Access Compliance Report

Public Rights-of-Way

Intersection ID: 27019	Main Street: ENDAHVEN_LN	Cross Street: ROUGEMONT_LN	Location: SE
ADA ID: 0CA05082CE1A	Ramp Type: PerpDiag	Initial Pass/Fail: Pass	Overall Compliance: No
Severity Score: 10.25			
Codes/Mitigation Info/Possible Solution		Field Measurements/Component Compliance

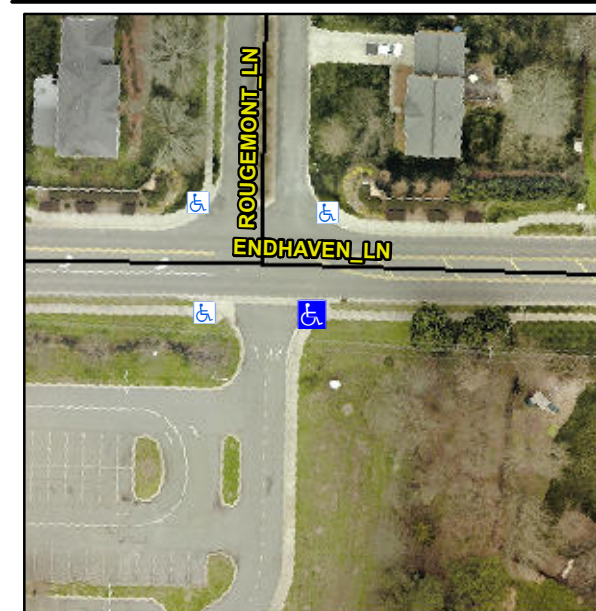
Remove & Replace Curb Ramp With Two New Directional Ramps or Equivalent.

R304.5.3, R304.2.1, R304.2.2-Perp, R304.3.2-Para, R305.2
